Access Compliance Report

Public Rights-of-Way

Intersection ID: 28255	Main Street: REA_RD	Cross Street: ARDREY_KELL_RD	Location: NE
ADA ID: EBAB822054CC	Ramp Type: Perp	Initial Pass/Fail: Fail	Overall Compliance: No
		Severity Score: 8.75

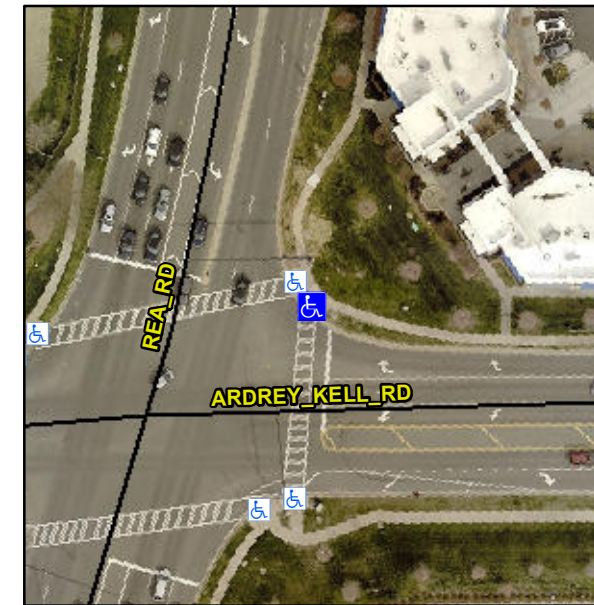
R304.5.1

Compliance	Description	Data	Compliance	Description	Data
N/A	Ramp Length (in)	71.0	Yes	Ramp Slope (%)	6.2
No	Ramp Width (in)	43.0	Yes	Ramp XSlope (%)	1.9
N/A	Flare Type LT	N/A	N/A	Flare Type RT	N/A
N/A	Flare Slope LT (%)	N/A	N/A	Flare Slope RT (%)	N/A
N/A	Flare Traversable LT?	N/A	N/A	Flare Traversable RT?	N/A
N/A	Landing Length (in)	N/A	N/A	DWS Provided?	N/A
N/A	Landing Width (in)	N/A	N/A	DWS Contrast?	N/A
N/A	Landing Slope (%)	N/A	N/A	DWS Length (in)	N/A
N/A	Landing X Slope (%)	N/A	N/A	DWS Full Width?	N/A
N/A	Landing Curb? (Y/N)	N/A	N/A	DWS Offset (in)	N/A
N/A	Shared Landing?	N/A			
N/A	Gutter Ponding?	N/A	N/A	Gutter Slope (%)	N/A
N/A	Gutter Lip Ht (in)	N/A	N/A	Gutter X Slope (%)	N/A
N/A	Painted X Walk1?	Yes	N/A	Painted X Walk2?	N/A
	X Walk 1 Direction	To SE		X Walk 2 Direction	N/A
N/A	X Walk 1 Width (in)	90.0	N/A	X Walk 2 Width (in)	N/A
	X Walk 1 Slope (%)	1.5		X Walk 2 Slope (%)	N/A
	X Walk 1 X Slope (%)	2.5		X Walk 2 X Slope (%)	N/A

Remove & Replace Entire Ramp.
